Addendum No. 04

The Construction of Crosby Sixth Grade Campus

Crosby ISD RFP# CSP 2526-0002

Addendum Number Four (04)
TO PLANS AND SPECIFICATIONS for
Crosby Sixth Grade Campus For Crosby ISD
STANTEC Project No. 214001329

Drawing No.
T101
2

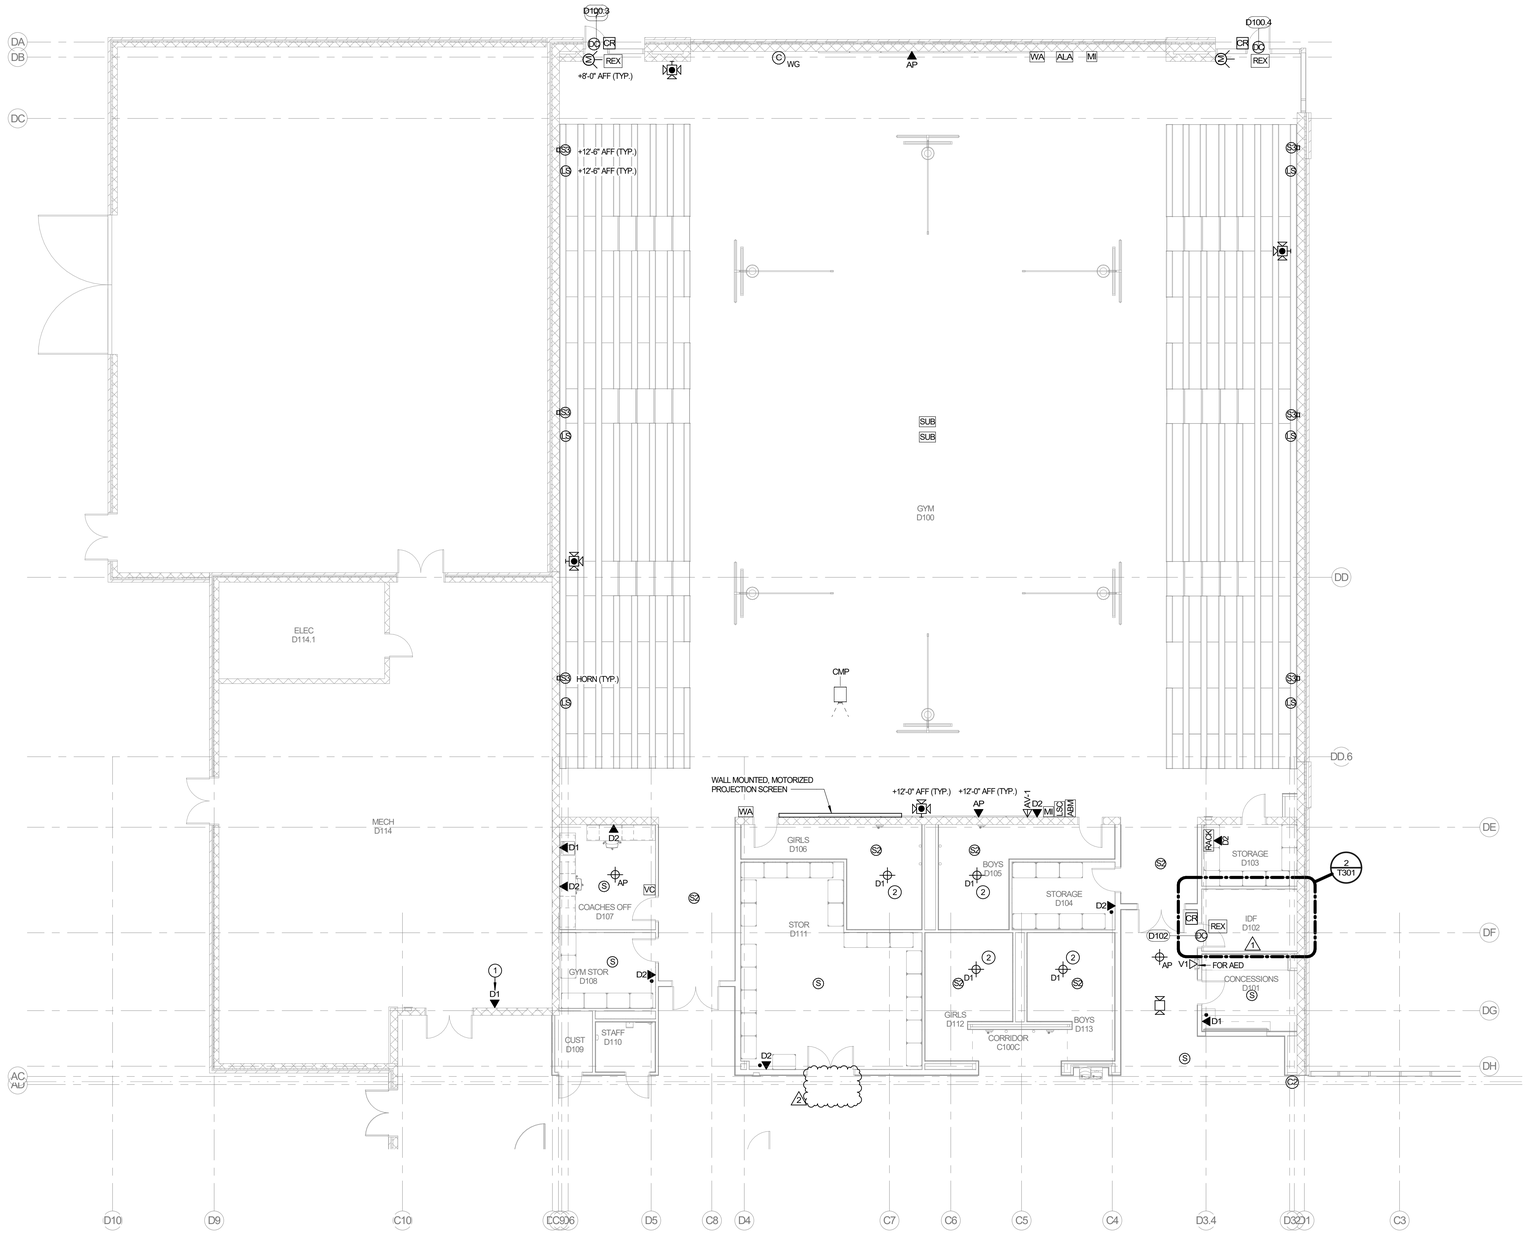
Q: Sheet T101 shows an underground pathway connecting the existing school building and the new school building. Please confirm whether a fiber-optic communication link is required between the two campuses.

R: refer to sheet T101 issued with addendum #4
